LE-South Houston TX, ADA Evaluation

Accessibility Evaluation

Inspection Date: 01/04/2023

Report Date: 01/12/2024

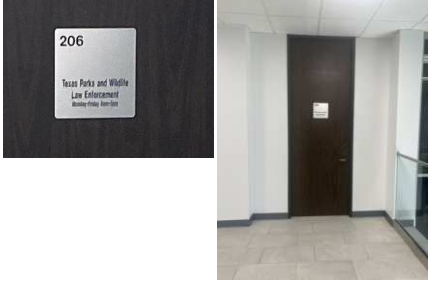
Finding Number	Area Description	Finding	As Built	Recommendation	Citation	Photos	Figure
14	Exterior of Property (Public) : Path of Travel to Building - Path of Travel (Main Route) Stone Sidewalk	The accessible path of travel between the building entrance and the accessible parking has cross slopes greater than 2%. Surface cross slopes shall not exceed 1 unit vertical in 48 units horizontal (2-percent slope).	There are several locations where exterior pathway exceeds 2% cross slope. Running slope of pathway within compliance. See additional photos for location of cross slope non compliance on accessible pathway to feature.	https://www.access-board.gov/ada/#ada-403_3	2012 TAS Section: 403.3 2010 ADAS Section: 403.3

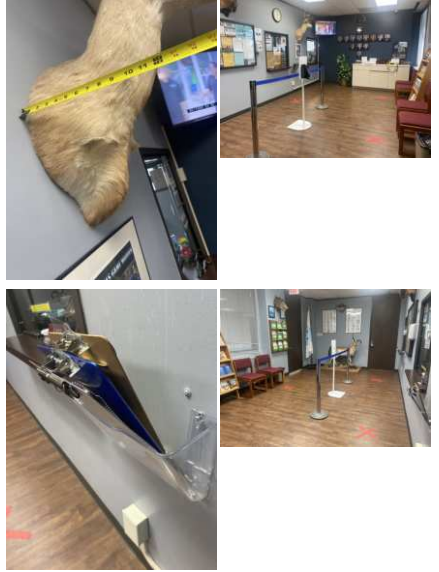
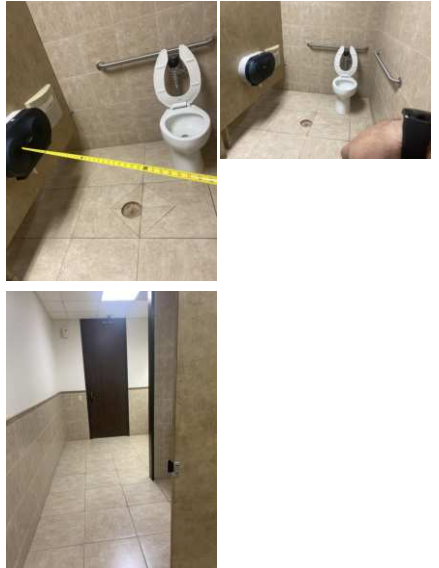
Finding Number	Area Description	Finding	As Built	Recommendation	Citation	Photos	Figure
16	First Floor Main Building LOBBY (Public): Exterior Entrance into Lobby (Accessible) - Entrance Doors	There is no ISA at this entrance. In existing buildings and facilities where not all entrances are accessible, entrances to buildings and facilities that are accessible to and usable by persons with disabilities shall be identified with an International Symbol of Accessibility (ISA). Typically this is 6 inches by 6 inches in size.	There are 2 main entrances into building. Entrance pictured is accessible and is missing sign indicating accessible entrance.	https://www.access-board.gov/ada/#ada-216_6	2012 TAS Section: 216.6 2010 ADAS Section: 216.6		
17	First Floor Main Building LOBBY (Public): Exterior Entrance into Lobby (Non Accessible)	There is no International Symbol of Accessibility at this entrance. In existing buildings and facilities where not all entrances are accessible doors that are accessible shall be identified by the International Symbol of Accessibility. Directional signs that indicate the location of the nearest accessible entrance shall be provided at entrances that are not accessible. Directional signs including the International Symbol of Accessibility indicating the accessible route to the nearest accessible entrance shall be provided at junctions when the accessible route diverges from the regular circulation path.	There are 2 main entrances into building. Entrance pictured is not accessible and is missing sign directing public to accessible entrance.	https://www.access-board.gov/ada/#ada-216_6	2012 TAS Section: 216.1 2010 ADAS Section: 216.6

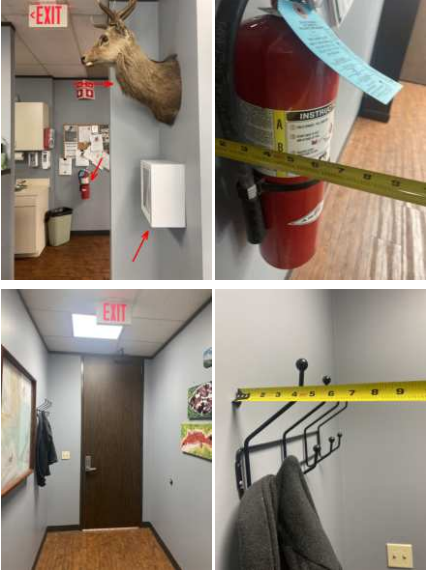
Finding Number	Area Description	Finding	As Built	Recommendation	Citation	Photos	Figure
41	Second Floor TPWD LE Office (Public): Interior Hallways of Building - Water Fountain	The drinking fountain projects from the wall into the pedestrian way with its leading edge above 27 inches from the floor. Objects may protrude no more than 4 inches into circulation route when located between 27 and 80 inches above the floor. All drinking fountains shall be positioned so as not to encroach into pedestrian ways.	Water fountain protrudes into walkway. Path must remain 36" wide to be compliant, needs verification.	https://www.access-board.gov/ada/#ada-307_2	2012 TAS Section: 307.2 2010 ADAS Section: 307.2
